PCN# 20130905003
Packing Material change for Select Devices on
QFN and VSSOP Package using 12mm Tape Width
Information Only

PCN Number:	20130905003			PCN Date:	09/12/2013
Title:	Packing Material change for Select Devices on QFN and VSSOP Package using 12mm Tape Width				
Customer Contact:	PCN Manager	Phone:	+1(214) 480-6037	Dept:	Quality Services
Change Type:					
☐	Assembly Site	☐	Assembly Process	☐	Assembly Materials
☐	Design	☐	Electrical Specification	☐	Mechanical Specification
☐	Test Site	☒	Packing/Shipping/Labeling	☐	Test Process
☐	Wafer Bump Site	☐	Wafer Bump Material	☐	Wafer Bump Process
☐	Wafer Fab Site	☐	Wafer Fab Materials	☐	Wafer Fab Process
PCN Details					
Description of Change:					
Packing Material change for Select Devices on QFN and VSSOP Package using 12mm Tape Width. Pack material differences are shown below: Current Packing for small SPQ (250units) – 13 inch reel diameter  ➔  Proposed Packing for small SPQ (250units) – 7 inch reel diameter  ➔

7 Inch Reel Drawing

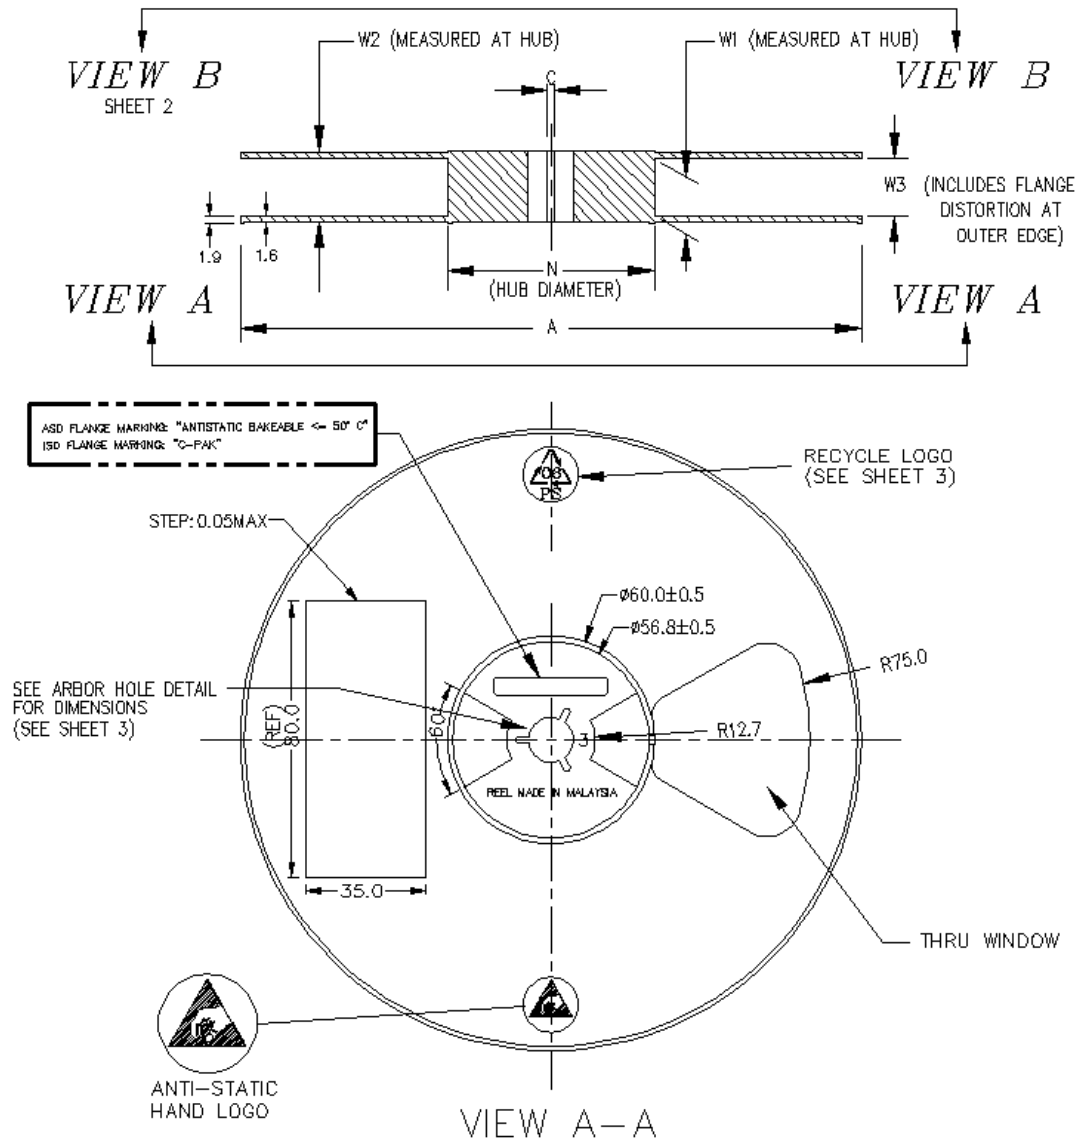
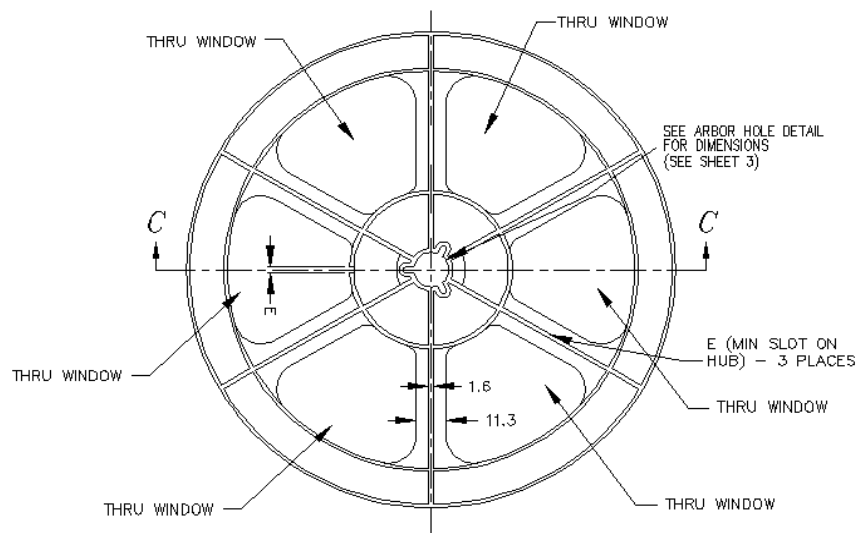
Pack BOM	Current for Full SPQ		Proposed for Full SPQ	
	TI /P/N	Details	TI /P/N	Details
Reel	4203160-0011	C-Pak 13" dia, 12mm width	4203839-0006	C-Pak 7" dia, 12mm width

(See Appendix A for 7 Inch diameter Reel Detail)
